PRATT & WHITNEY CANADA
SERVICE BULLETIN

P&WC S.B. No. 41046R2

TURBOSHAFT ENGINE
PT SPEED AND TORQUE SENSOR, LEFT HAND - REPLACEMENT OF

PT6C-67C

Measuring Tool PWC72018
Figure 1

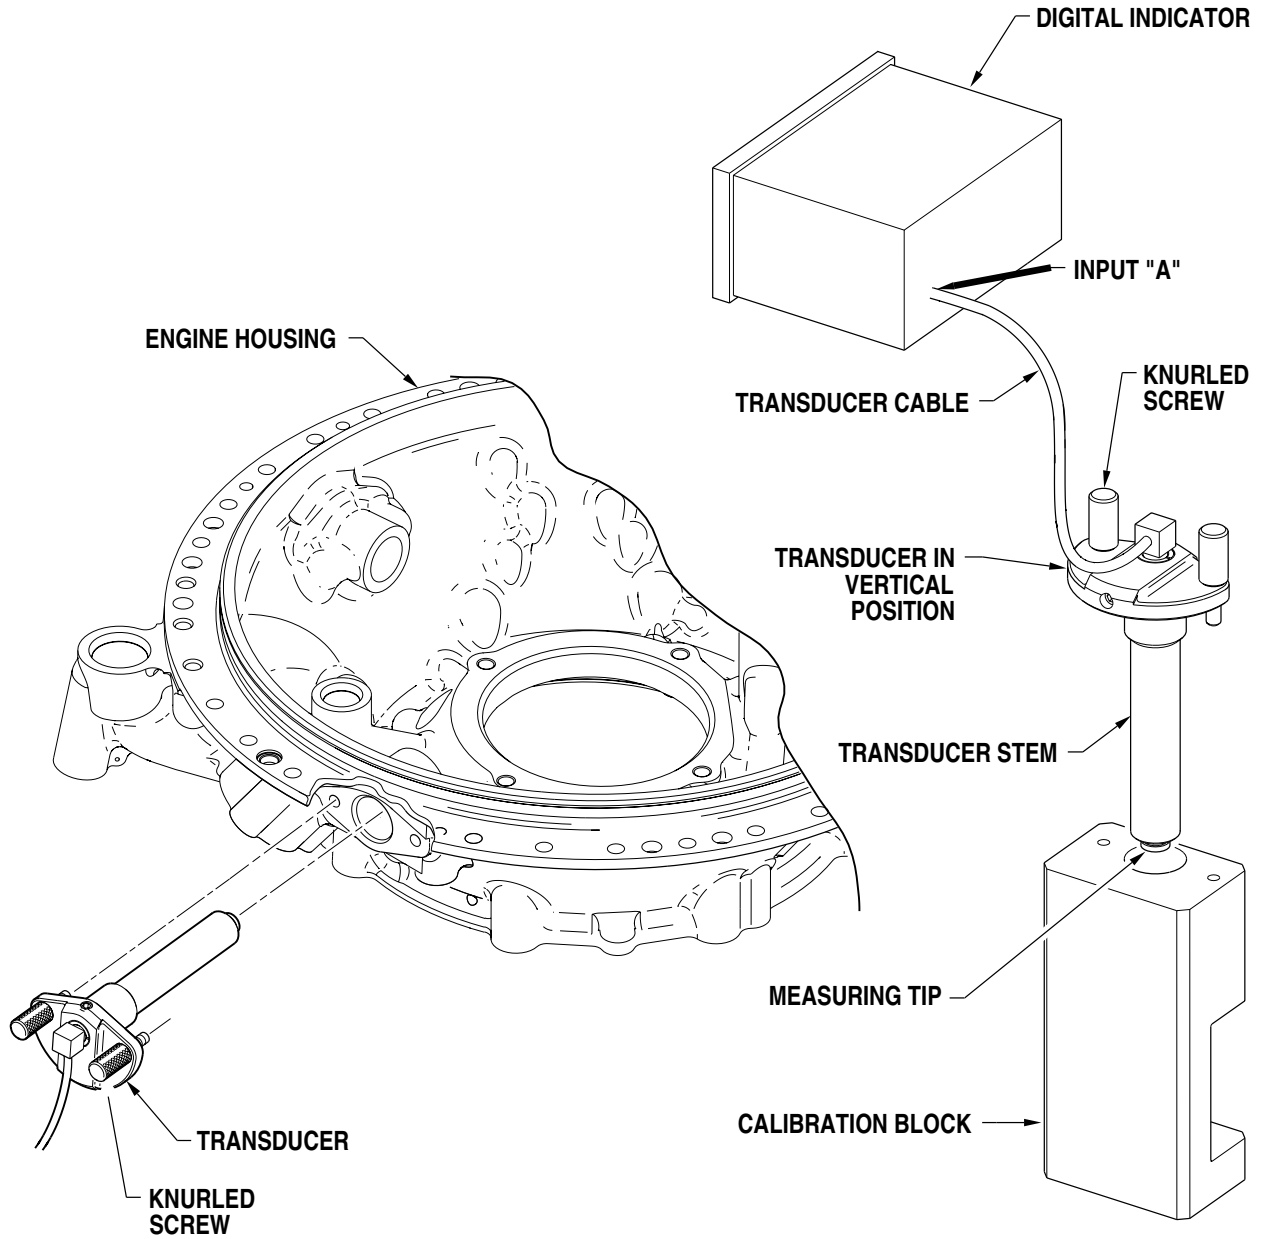
- (1) Determine the correct shim thickness as follows:

- (a) Do the calibration of the measuring tool P/N PWC72018 as follows:

- 9 Add the value recorded in the previous step to the value indicated on the calibration block. The result must be between 3.910 and 3.915 inch. If the result is within the specified range, go to step 10. If the result is outside the specified range, it is possible to adjust the transducer as follows:

PT Speed and Torque Sensor, Left Hand - Installation
Figure 2

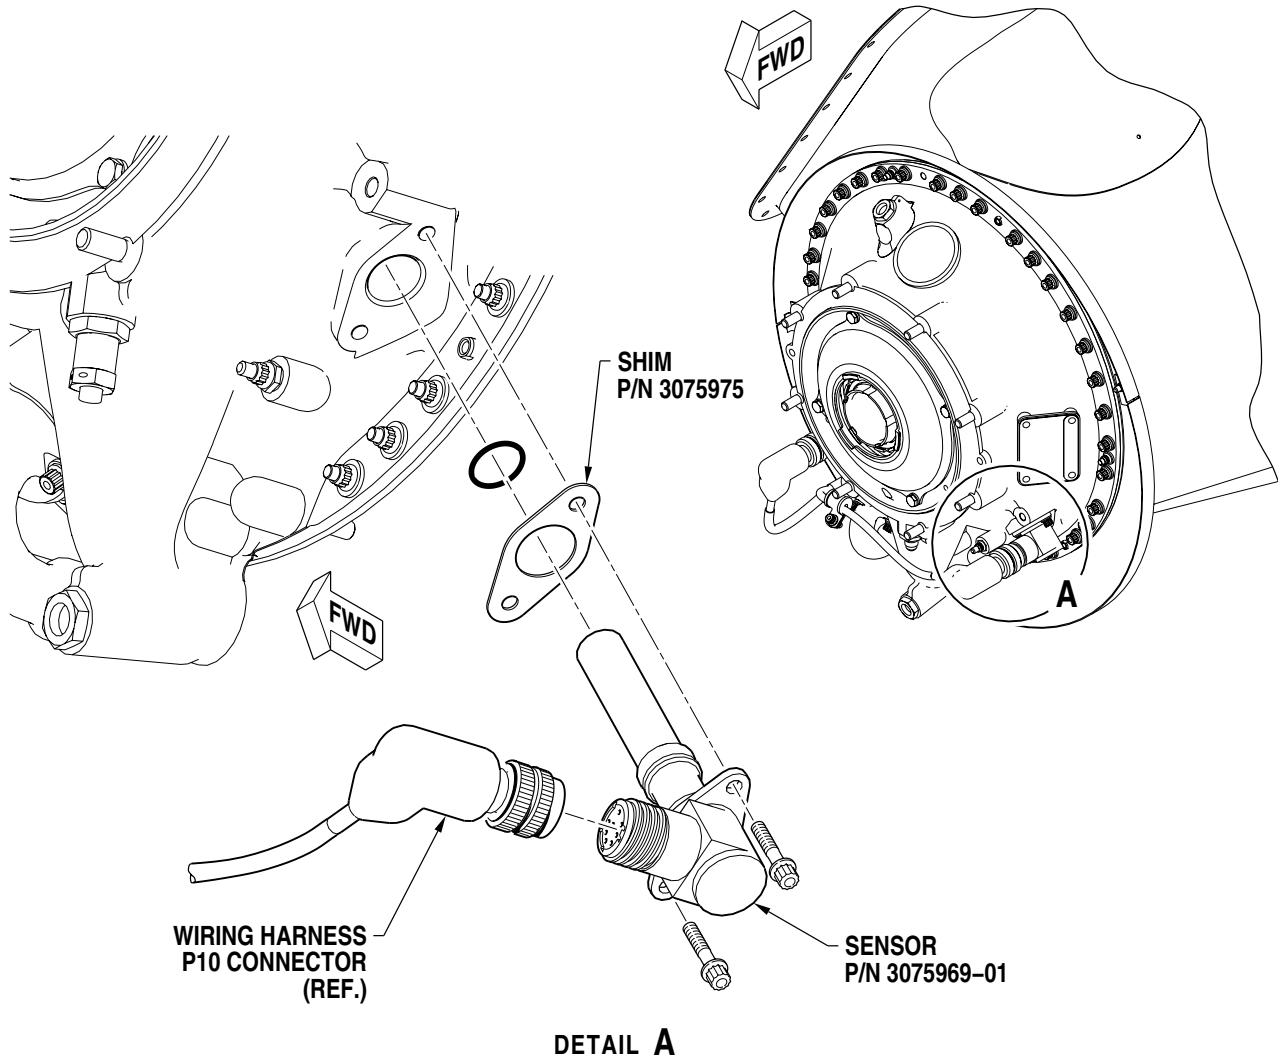
Introduce a new torque sensor, on the left side, with shims to adjust the gap between the sensor and torque shaft.

Replace the left sensor with a new sensor installed with shims.

- B. Install the parts listed under New P/N in Para. 2.D., Material Information, per the maintenance manual instructions (Ref. 77-10-00) with the differences that follow (Ref. Fig. 1 and 2 and Tables 1 thru 4):

- (h) Round off to the highest recorded value in Table 1 (in the positive direction) within 0.001 inch. Use this highest value in Table 2 to determine the correct shim thickness.
